Application No: DEV2022/1295

Site Location: 905 Flagstonian Drive, Flagstone

Application Description: Development Permit for a Material Change of Use for Child Care Centre and Indoor Sport and Recreation (Swim School)

Subject: Response to EDQ's Further Issues – Traffic Matters

Vehicle Tracking Diagram – Heavy Rigid Vehicle

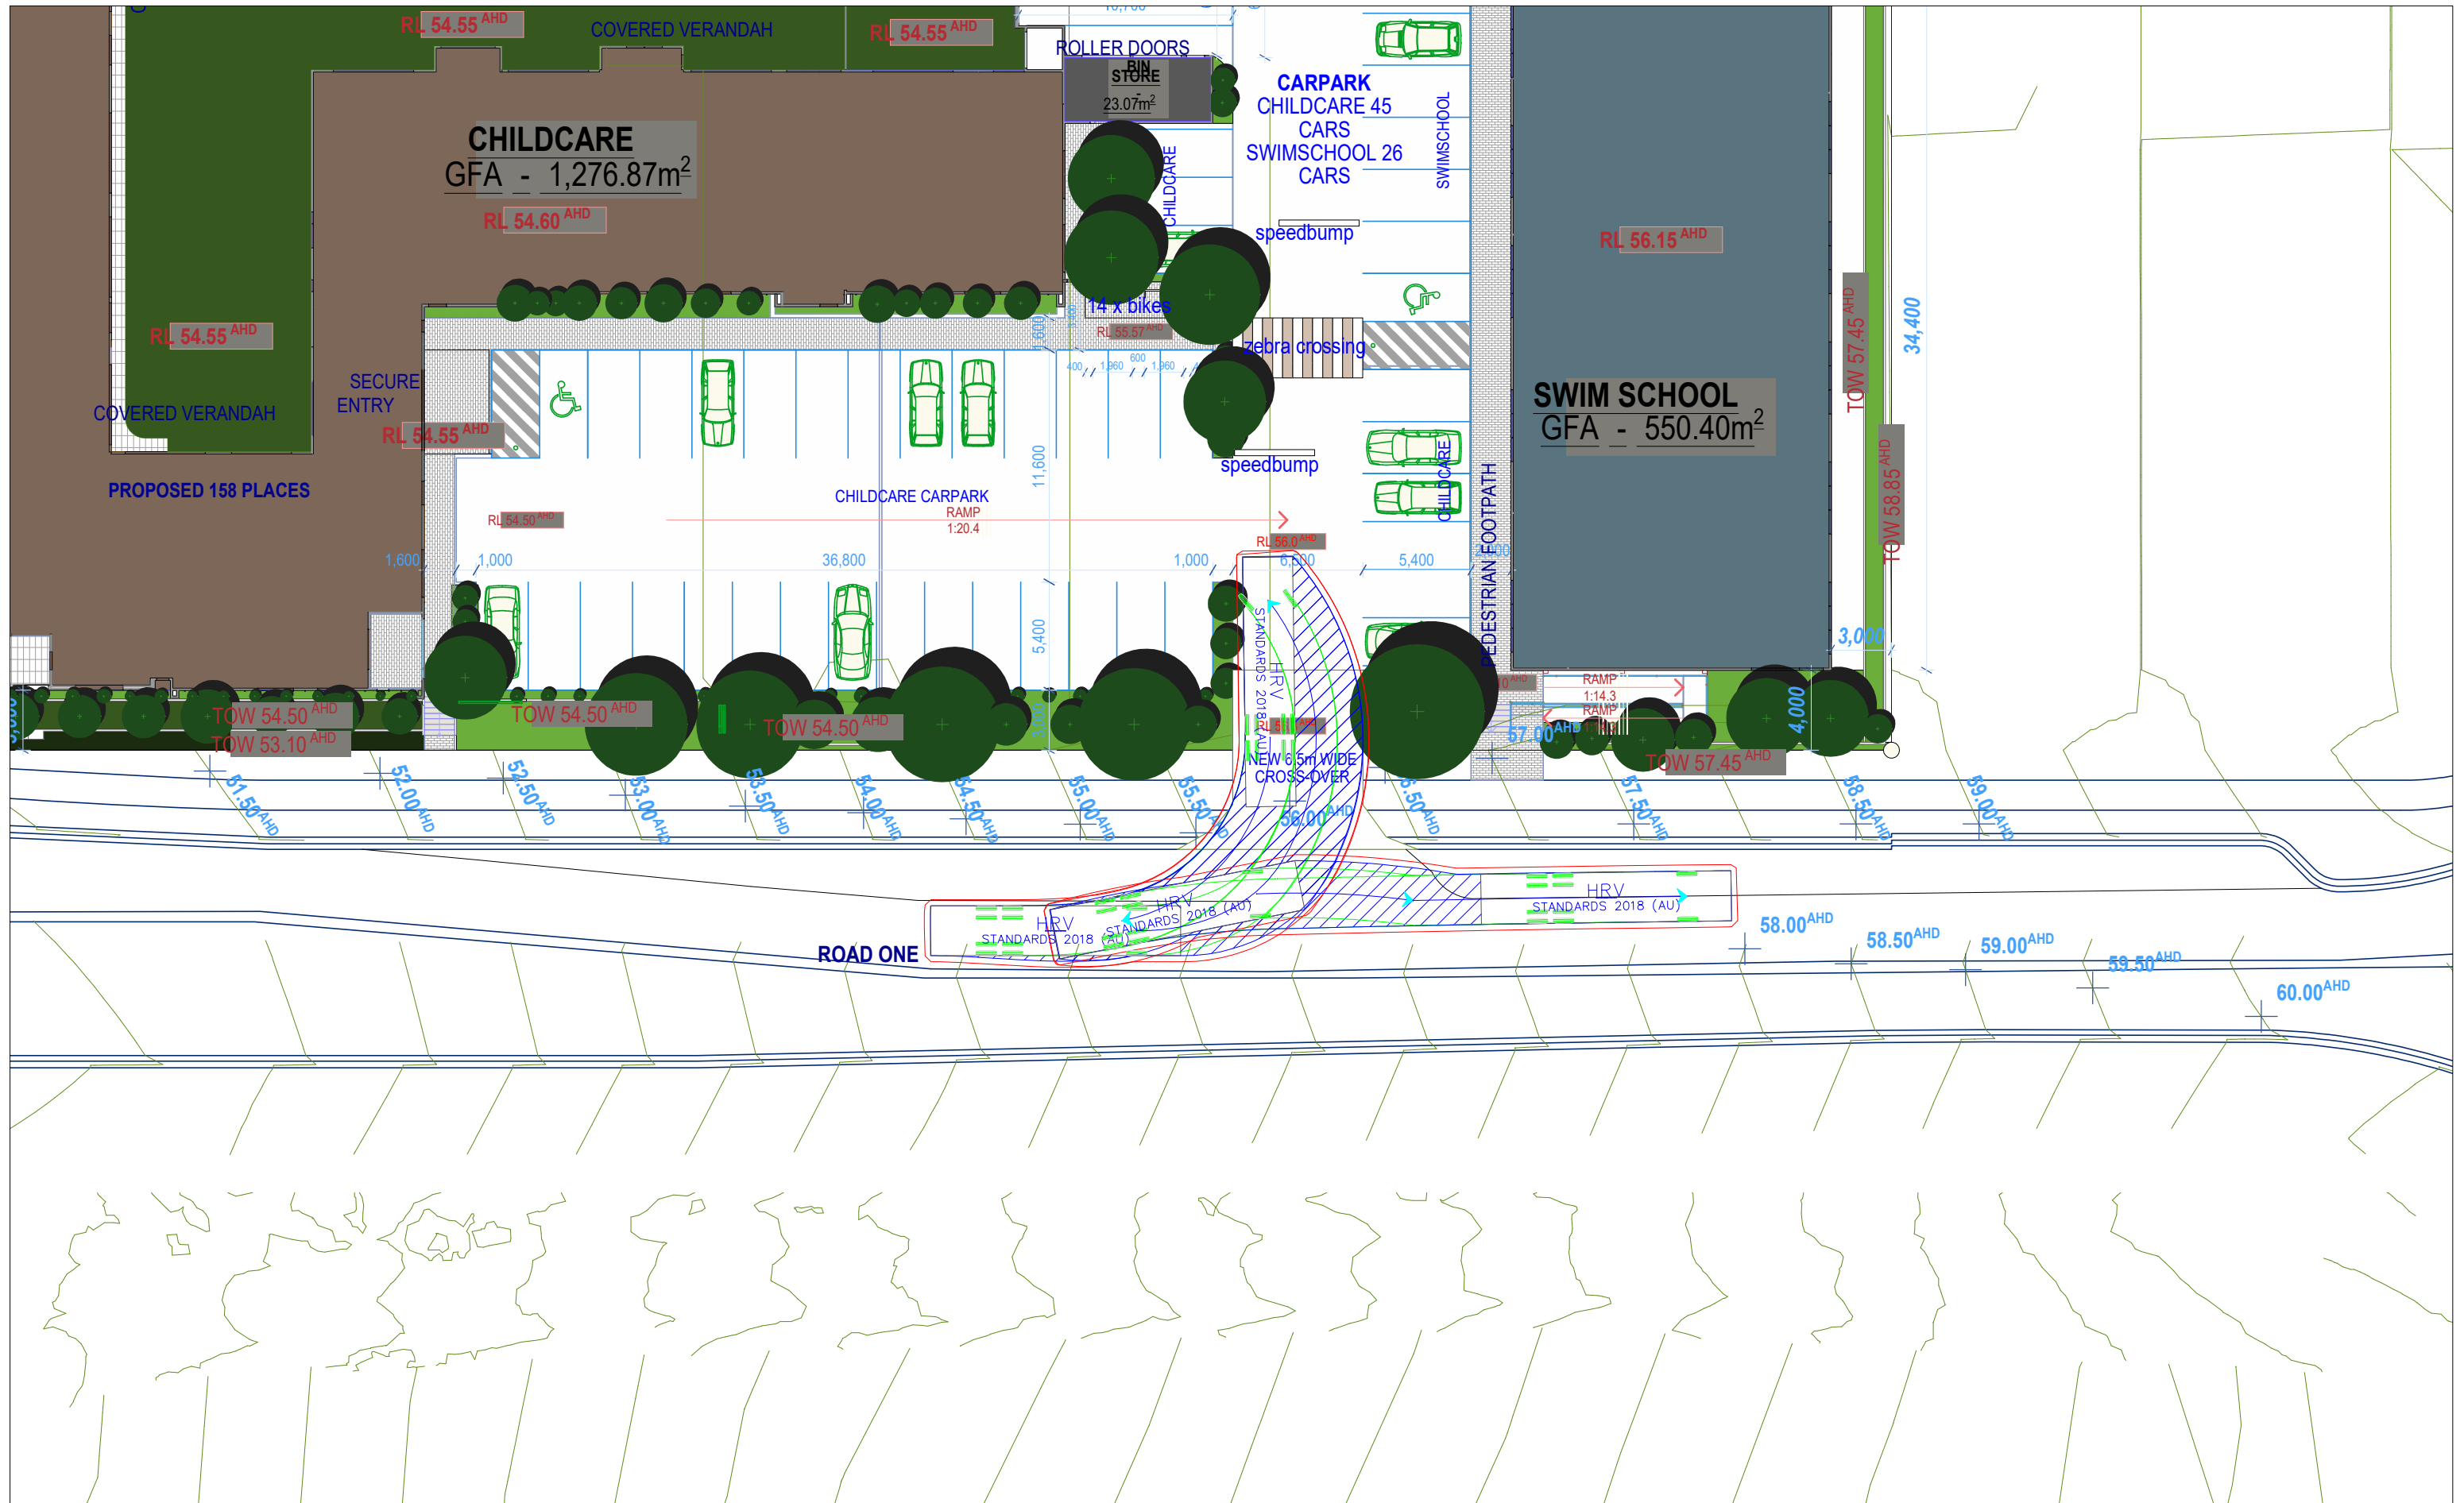
a. Submit swept path diagrams which shows the central median on Road 1 (College Drive) and confirms that the ingress and egress swept path of the refuse vehicle does not impact on this median.

b. Confirm the waste collection vehicle dimension is consistent with Logan City Council.

As shown in the vehicle tracking diagram included as **Attachment 2**, up to a 12.5m long Heavy Rigid Vehicle would be able to enter/exit the site without the wheelpath of the vehicle conflicting with the central median, or the body of the vehicle overhanging past the central median into the opposing traffic lane.

Notwithstanding the above, it is considered unlikely that the largest vehicle requiring access to the site would exceed a 10.4m long refuse collection vehicle. A vehicle of this size would comfortably be able to enter and exit the site without conflicting with the central median, as shown in the vehicle tracking diagram included as **Attachment 2**.

Based upon our experience, the largest rear-loading refuse collection vehicles used for on-site refuse collection are typically approximately 10.24m in length, therefore a standard vehicle length of 10.24m is typically used in vehicle tracking analyses (noting that the manoeuvring requirements for a vehicle of this size vs a slightly larger vehicle of say 10.3m – 10.4m are typically very similar to those of a 10.24m long vehicle).

Reference has been made to the Logan City Council Planning Scheme which mentions a rear-loading refuse collection vehicle length of 10.3m (albeit for rear lot residential properties) in Note 2 of Table 3.4.5.1.2. It is therefore assumed that this is an appropriate assumed design vehicle length for a rear-loading refuse collection vehicle, for on-site collection.

As shown in the vehicle tracking diagram included as **Attachment 2**, a refuse collection vehicle of 10.4m length would comfortably be able to enter and exit the site in a forward direction, and manoeuvre on-site as required for refuse collection.
